Re: Information request response for Pedersen's Road, Dangore.

SARA Information Request – Pedersens Road, Dangore

TUMBLIN QUARRY (IR RESPONSE)

Traffic and Pavement Impact Assessment

Figure 1.1: Design Vehicle Configuration

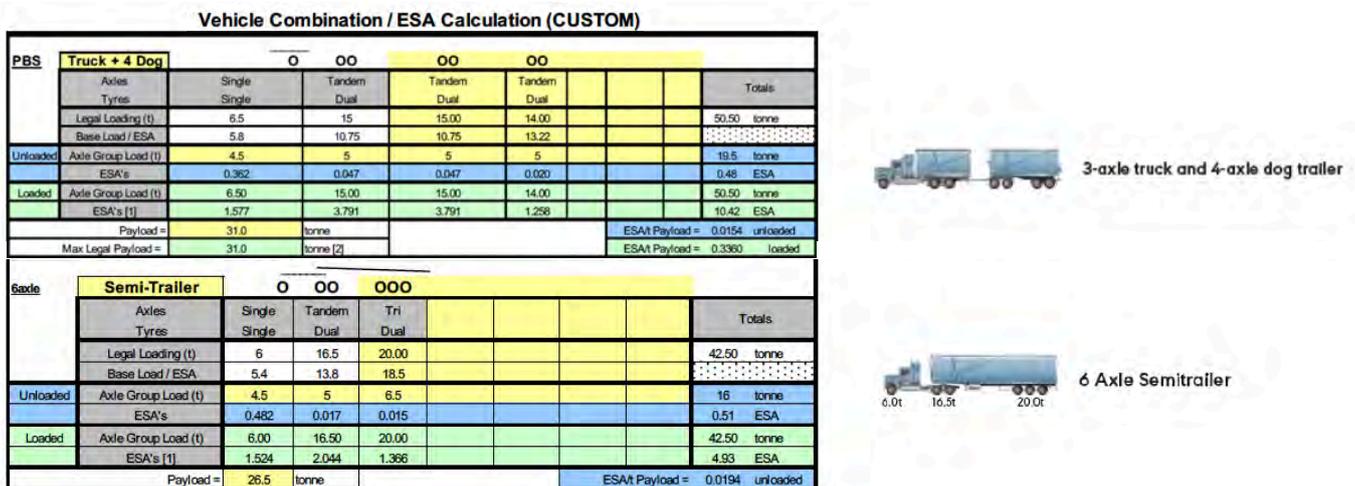
<p>a) Be based on a haul vehicle configuration that can use the Memerambi Gordonbrook Road for general access, without the need for separate approval from the National Heavy Vehicle Regulator.</p> <p>b) Be based on the haul route specified as Route A in the submitted traffic report.</p> <p>c) Identify the number and type of axle groups of the haul vehicle(s), as well as the maximum load on each individual axle group both when the haul vehicle is loaded and unloaded. The maximum Gross Vehicle Mass for the haul vehicle shall not exceed 42.5 tonnes Gross Vehicle Mass and 19 metres in total length or Level 1 PBS.</p> <p>d) Update and resubmit the pavement contribution calculations based on the vehicle configuration in item (a) for the identified haul route requested in item (b), in accordance with Section 13 of the GTIA.</p> <p>e) Submit a Road Safety assessment of the haul route specified in item (b) prepared in accordance with Section 9 of the GTIA. In particular, whether the increased heavy vehicle traffic generated by the proposed use will have an impact on the narrow unformed section of Memerambi Gordonbrook Road.</p> <p>f) Where impacts are identified, propose recommendations to ameliorate the development's impact on the State-controlled road network. Where the recommendations involve road work upgrades on the State-controlled road, submit conceptual geometric design drawings to demonstrate that the works' design can comply with Normal Design Domain criteria specified in the Department of Transport and Main Roads' Road Planning and Design Manual 2nd Edition and be wholly contained within existing road corridors.</p>

- a) The assessment has been updated to adopt a 42.5 tonnes Gross Vehicle Mass Articulated Vehicle and a Level 1 PBS Truck and Dob Combination with Gross Vehicle Mass of 50.5 tonnes.
- b) Haulage Route B has been removed from this version of the analysis.
- c) See Figure 1.1.
